EDMS NO.
1973010

REFERENCE
LHC-TC-EC-0012

ENGINEERING CHANGE REQUEST

Installation in IR2 of dispersion suppressor collimators (TCLD)

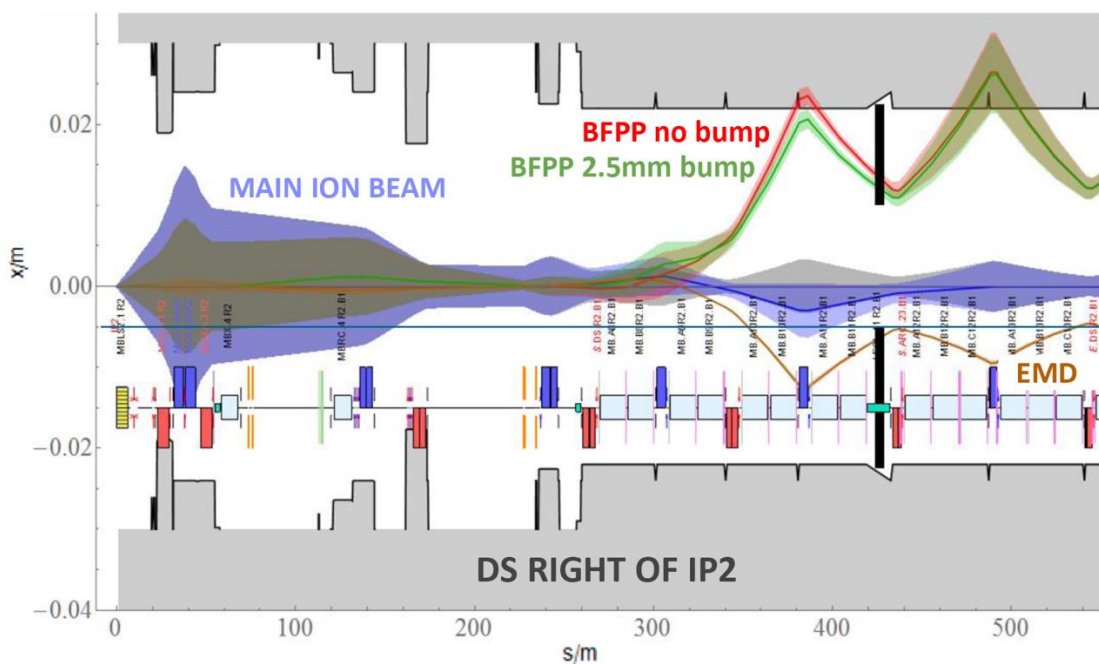
The magnets that are impacted by these losses are likely to quench at the high luminosities foreseen for HL-LHC. As alleviation, it is planned to install additional collimators (shown as black lines in Figure 1).

As can be seen in Figure 1, these secondary beams are lost very locally due to the large and sudden change of magnetic rigidity at the interaction point. After the LS2 ALICE upgrade, aiming at a peak luminosity of $6 \times 10^{27} \text{cm}^{-2} \text{s}^{-1}$ (about six times higher than the nominal one) [3], the dominant BFPP1 beam can carry about 155 W,

During standard operation, special bumps were deployed around ATLAS and CMS to steer the BFPP1 losses into the locations of the connection cryostat, however, because of the quadrupole polarities in IR2, this solution alone is not possible at ALICE. Instead, the HL-LHC baseline is to install one additional collimator, called TCLD, on each outgoing beam in the IR2 dispersion suppressor, where the dispersion is already rising [3]. Orbit bumps ensure that the beam is not lost at the first (lower) dispersion peak (see Figure 1) and enable shifting the losses into the collimators. By closing their jaws further, these TCLDs can also intercept the most powerful EMD beam (EMD1) that would otherwise be lost in IR3. FLUKA simulations have shown that the proposed TCLDs reduce the peak load on the magnets to tractable levels at HL-LHC design luminosity [4].

Figure 2 – One of the TCLD jaws, including RF fingers, cooling pipes and BPMs. Courtesy of L. Gentini – SmarTeam number ST0676575.

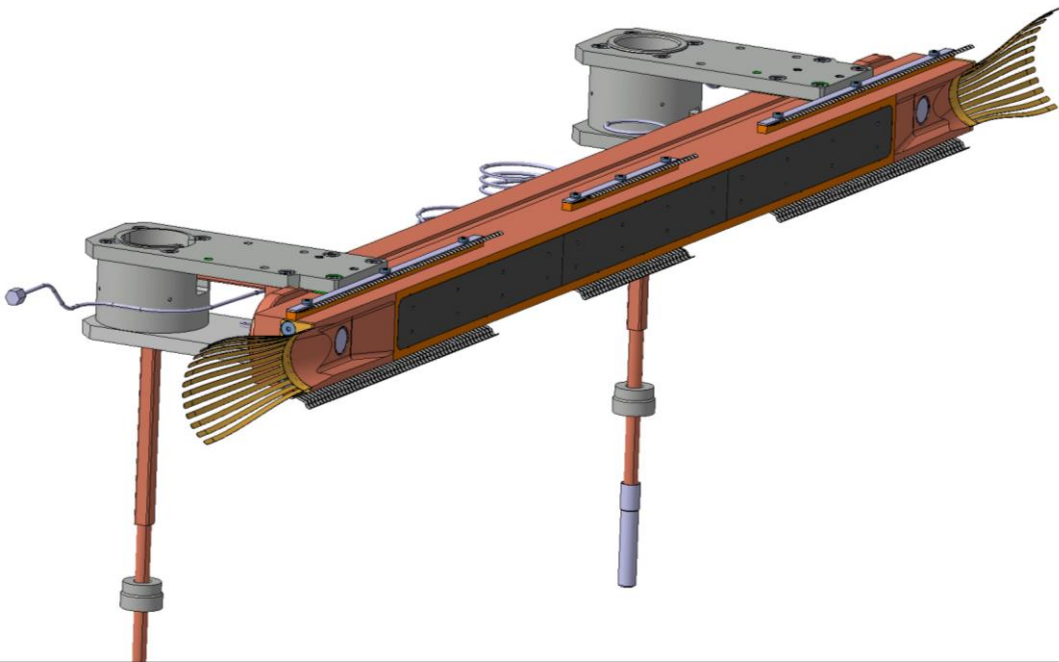
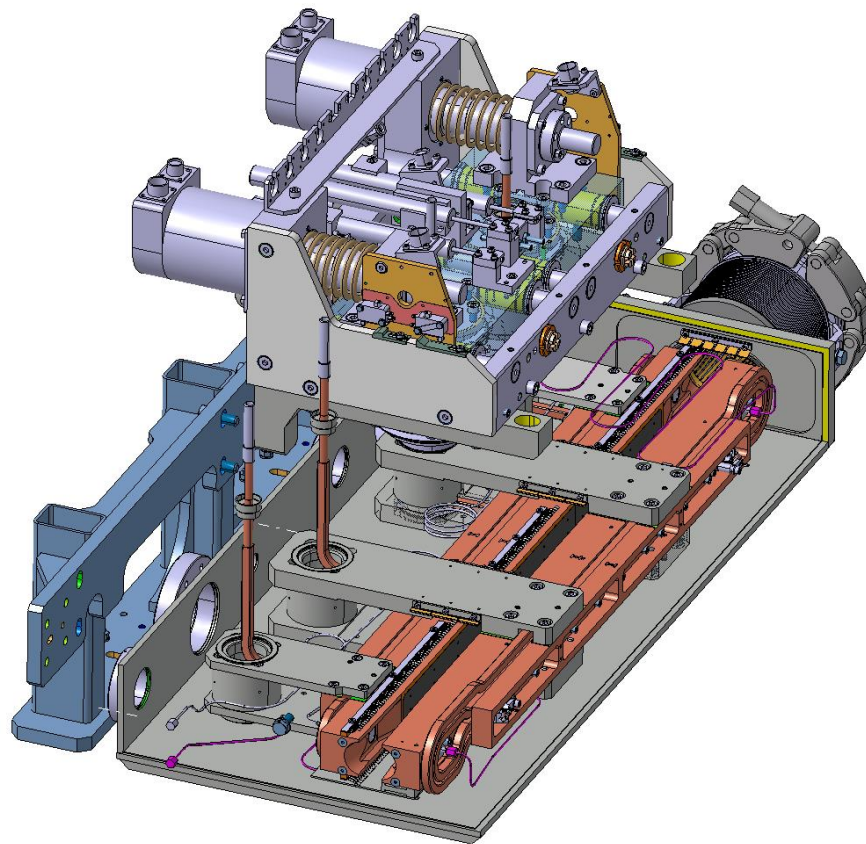
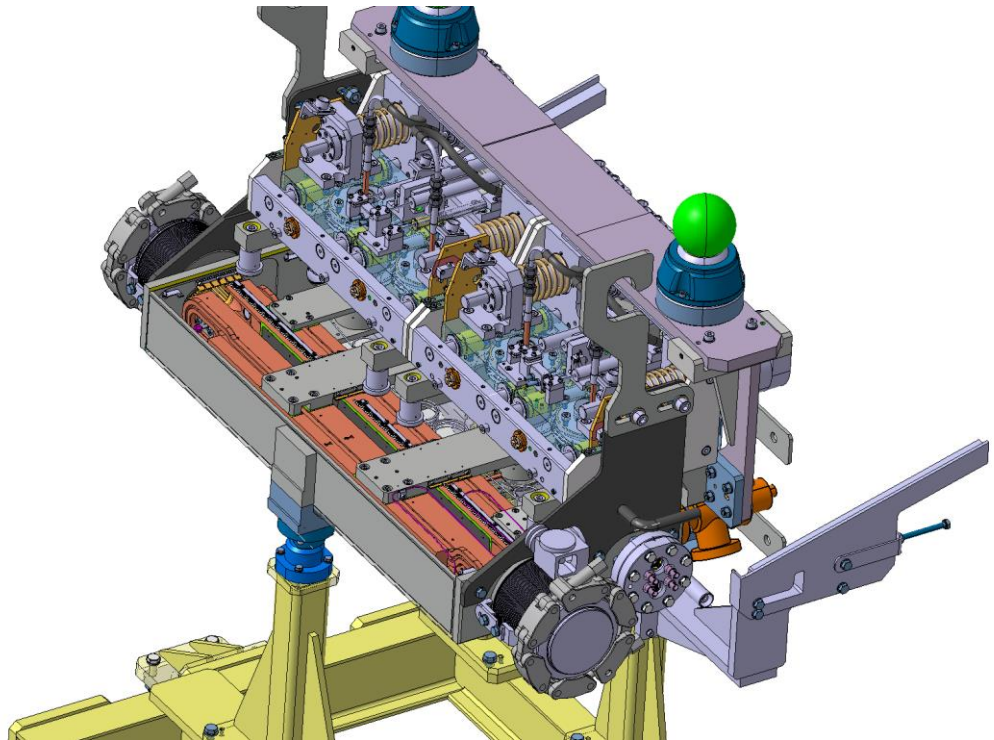
Like most other LHC collimators, the TCLD consists of two parallel jaws collimating the beam in the horizontal plane, with the beam passing in between them. The active material of the jaws is the tungsten alloy Inermet 180. The design of the TCLD collimator, shown in more detail in Figure 2, Figure 3 and Figure 4, is derived from the design of the present LHC collimators, but with some differences. Since the design of

the IR2 TCLDs is identical to that of the IR7 ones, and because of the very tight space requirements in IR7, the design is challenging and the active length of the material had to be reduced to only 60 cm, in order to make it fit. This also means that a non-standard support design is used. Furthermore, the bellows at the two longitudinal extremities are integrated in the tank transitions in order to gain longitudinal space. Special tooling for transport, handling and for the retraction of the collimator bellows during the installation has been designed. In order to gain as much space around the TCLD vacuum tank as possible, a new thinner set of heating jackets (aerogel) has also been produced. A 3D drawing of the tank and support is shown in Figure 5. The SmarTeam references are shown in Table 1.

The actuation system does not include any movement in the vertical plane, which allowed reducing the jaw height. Otherwise, each jaw can be independently moved by two stepping motors per jaw, which maintains the possibility to tilt the jaws in the horizontal plane. The maximum opening of each jaw is 25 mm from the centre, 5 mm less than for standard collimators, and the stroke across the centre is 5 mm.

As all recent collimators, the design includes two BPMs per jaw, integrated at the extremities outside of the tapering. The jaws feature water cooling, using squared 9 mm pipes. Each jaw contains also 3 LVDT position sensors and 2 TP100 temperature sensors.

Figure 6 – The assembly to be installed at the location of the IP2 connection cryostats, consisting of TCLD collimator, support, beam pipe for the other beam, and cryo-bypass. Courtesy of L. Gentini – SmarTeam number ST0676575.

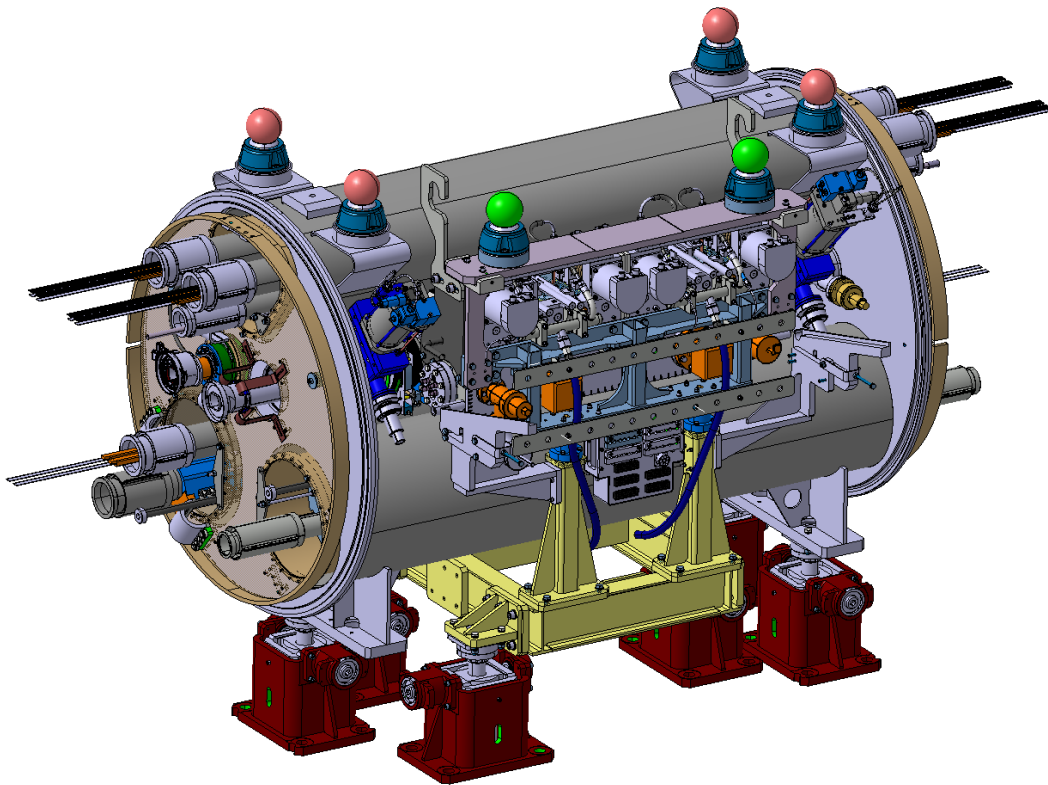
This requires that the present ~ 12 m long connection cryostats are removed so that each can be replaced by an assembly consisting of a pair of 5.3 m-long cryostats (LEP) with a 2.2 m bypass cryostat in the middle (LEN), as well as the TCLD collimator. The bypass cryostat comes in two different configurations, one for each beam line, depending on whether it is the collimated or the non-collimated line. The cryo-assembly is described in a separate ECR under the responsibility of WP11 [6].

The TCLD will be integrated in a specially designed assembly, containing a beam pipe for the other beam, as well as a cryo-bypass, which is needed since the TCLD is a warm element placed between two cold ones. This assembly, which is discussed more in detail in a separate ECR, is shown in Figure 6. The vacuum flange used for the TCLD is the DN100 with internal diameter of 64 mm.
